5TH AND VIRGINIA

Proposed MUP #3018037

# SECTION 02. RESPONSE TO EDG

Perspective from Escala Balcony, Level 18, Facing South

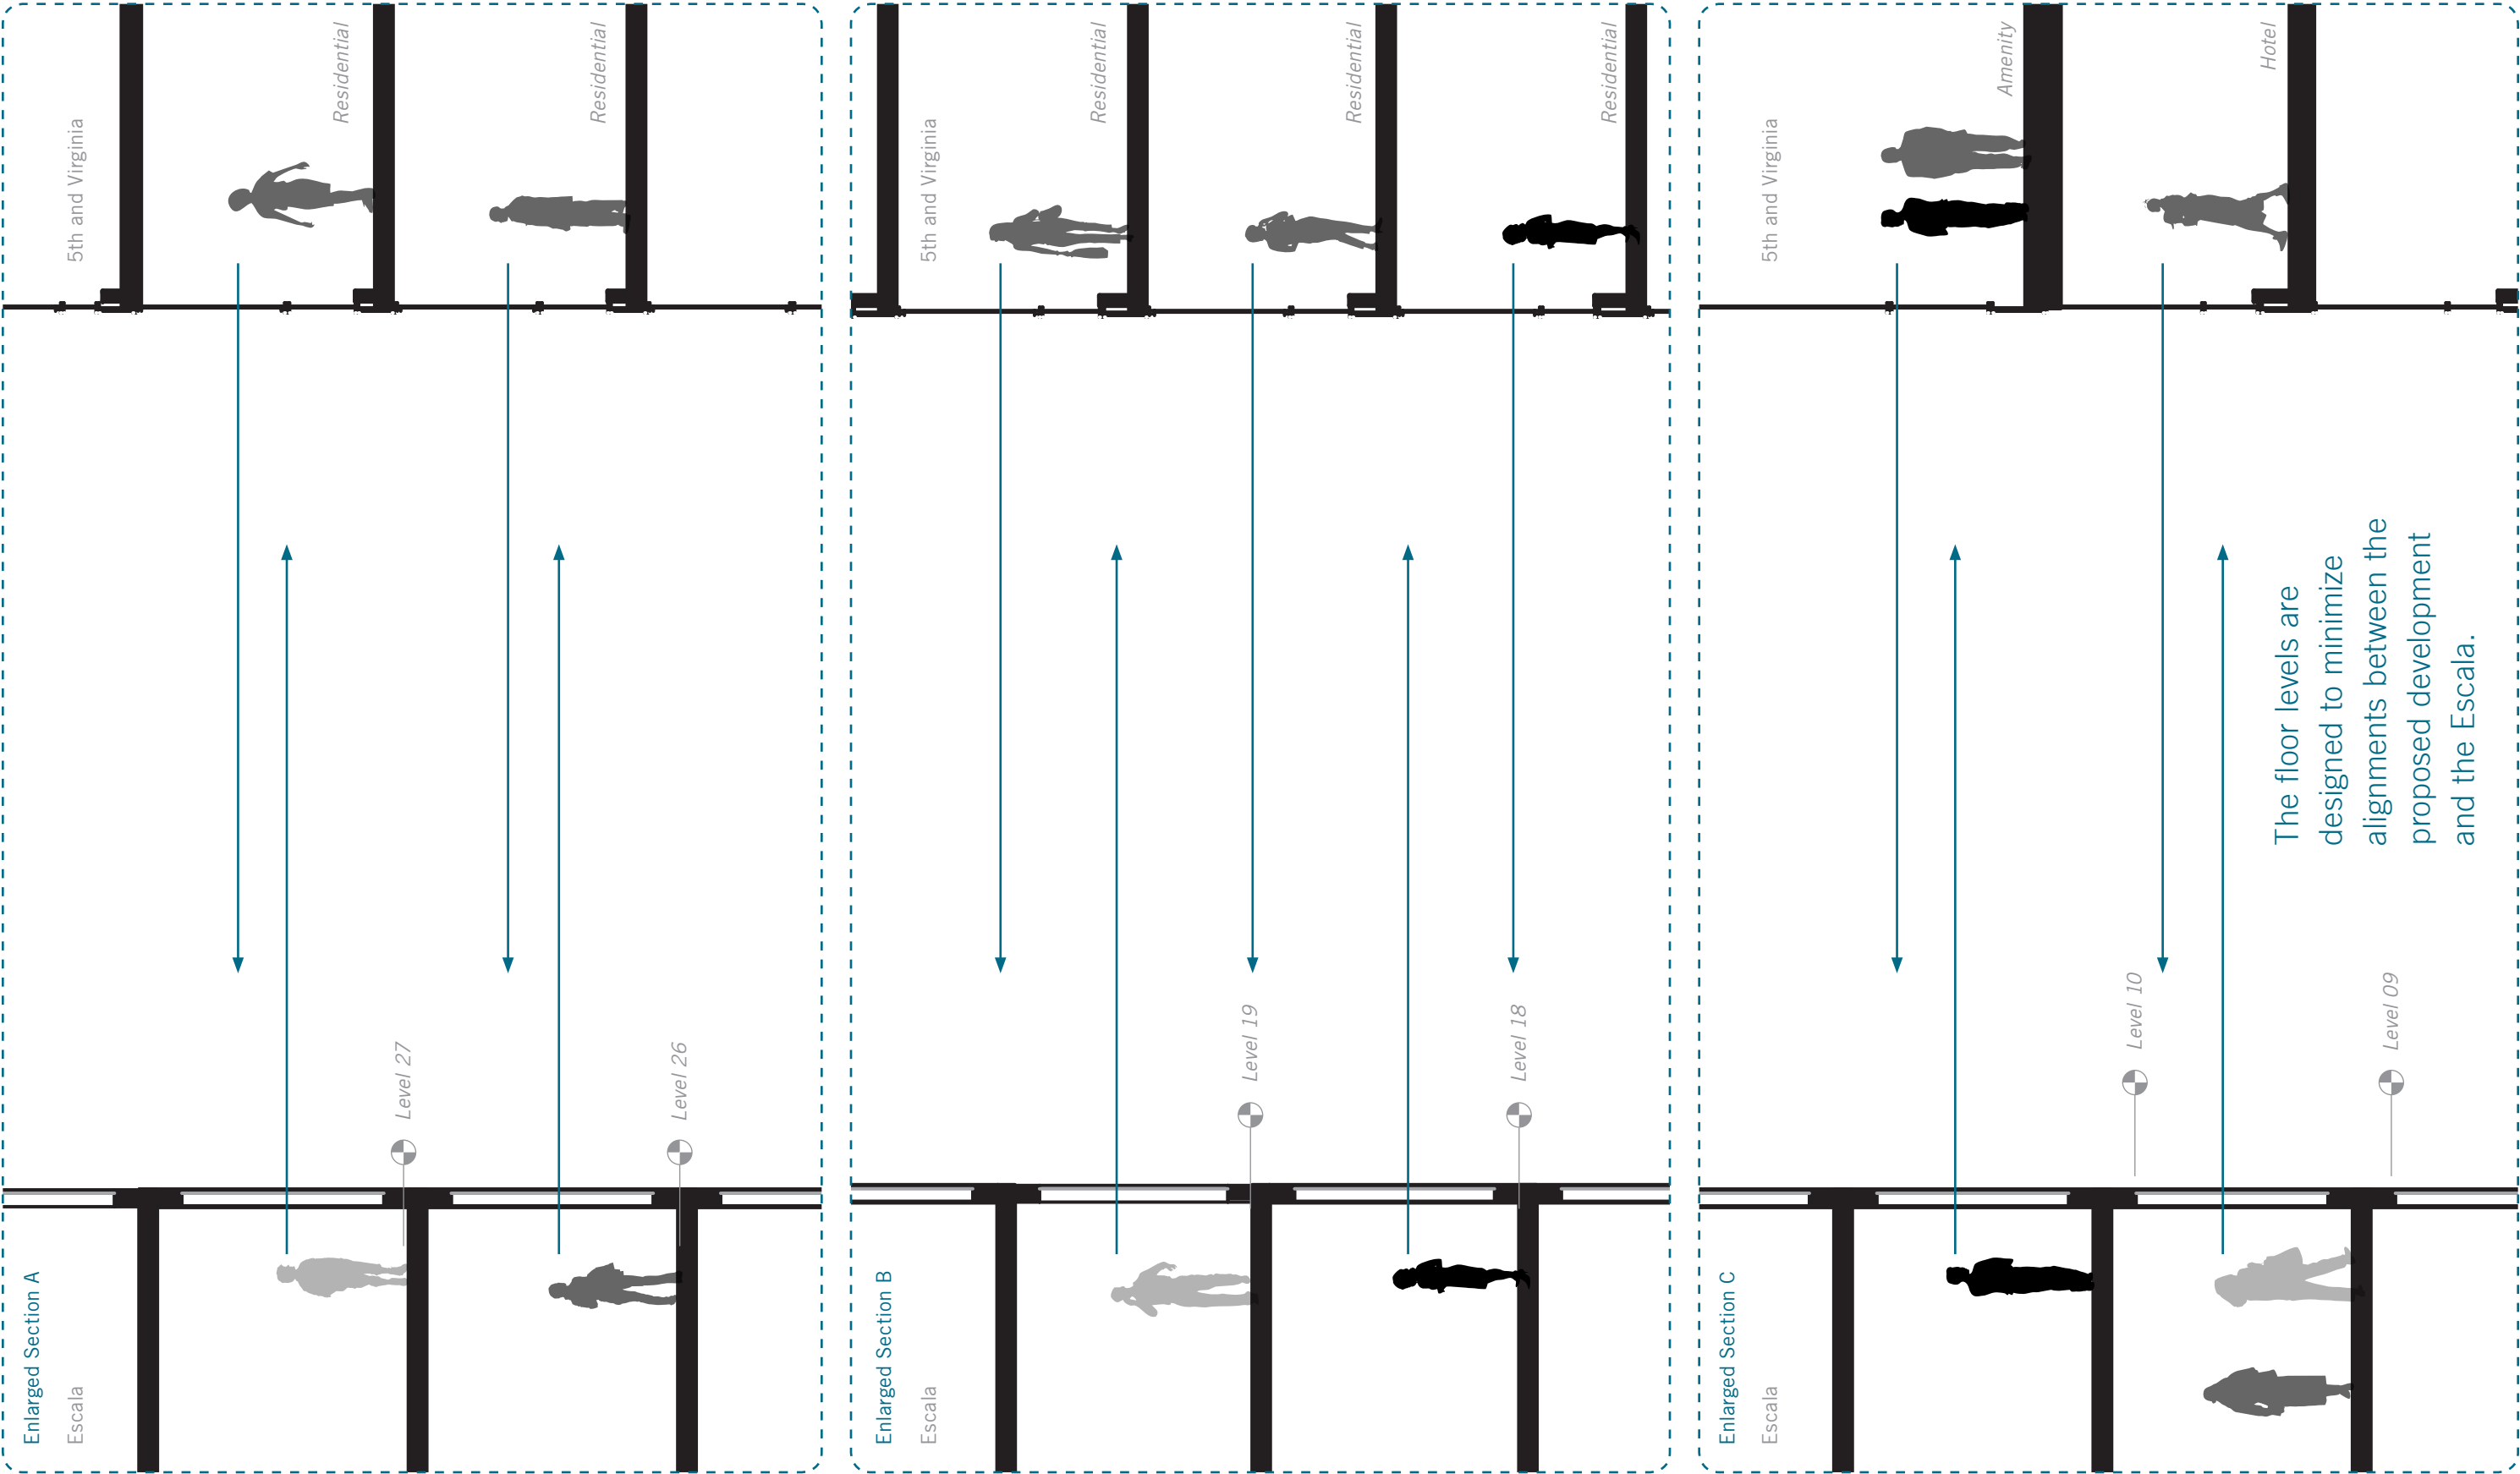
Whatever the final shape of the west wall (5d above), the Board strongly reiterated the guidance under EDG#1, item 2b, and further recommended the following to ensure reasonable privacy between the two buildings: First- the proposed hotel rooms and units at the west corners of the tower should have windows mostly - if not entirely- oriented to the south or north. Second - the west wall depth should be substantial (14-24” advised) to provide for canted windows and other techniques to ensure unit to unit privacy, especially between living rooms and at the central portions of floors 4-19, where corner re-orientation is not possible. Other techniques such as louvered privacy windows, one-way films, vertical slot windows, etc should also be considered. (B1.I)

The design has been substantially modified in response to DRB guidance to address adjacency concerns. Numerous significant changes have been made as follows:

- 6. Privacy shades will be provided at all west facing windows.
- 7. Interior layouts have been modified with special care taken to locate living spaces and window locations to minimize overlaps with living spaces in the neighboring building.
